# The user manual for EV3635B

Rev 1.0

## Schematics

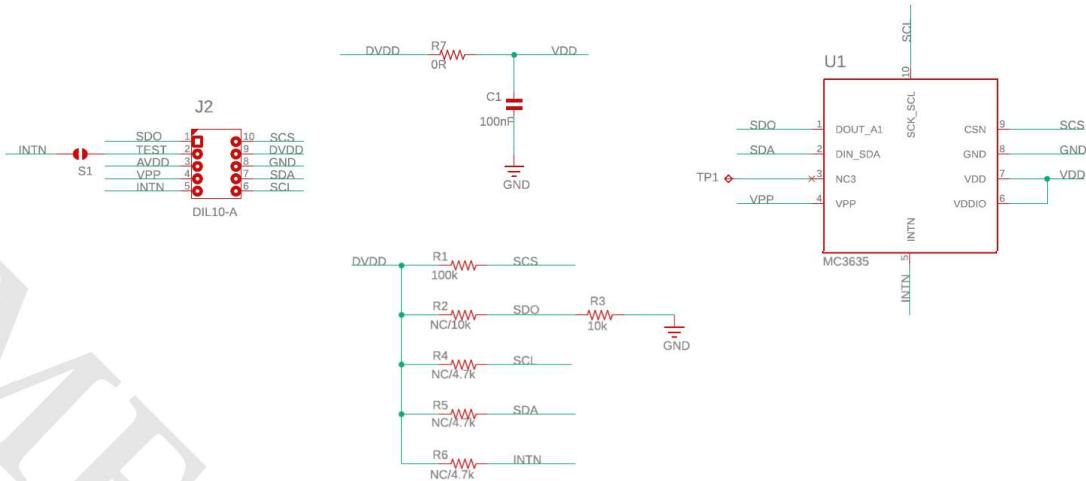
EV3635A (PCBA, PCB Assembly) and EV3635B (PCBA) use the same PCB, on which it is the same silk print "EV3635A" (refer to Picture 1 and Picture 2 below). The differences between EV3635A (PCBA) and EV3635B (PCBA) are that resistors' values are different and whether the resistors are stuffed (refer to Table 1, Table 2, and Schematics below).

Interface (EV3635B)	R1	R2	R3
SPI or I2C 0x4C (Factory Default)	100KΩ	DNI	10KΩ
SPI or I2C 0x6C	100KΩ	10KΩ	DNI

Interface (EV3635A, Obsolete)	R1	R2	R3
SPI (Factory Default)	4.7KΩ	4.7KΩ	DNI

Notes: If I<sup>C</sup> is used, and there are no pull up resistors on MCU board or inside MCU, R4 and R5 need to be populated by 4.7k resistors then.
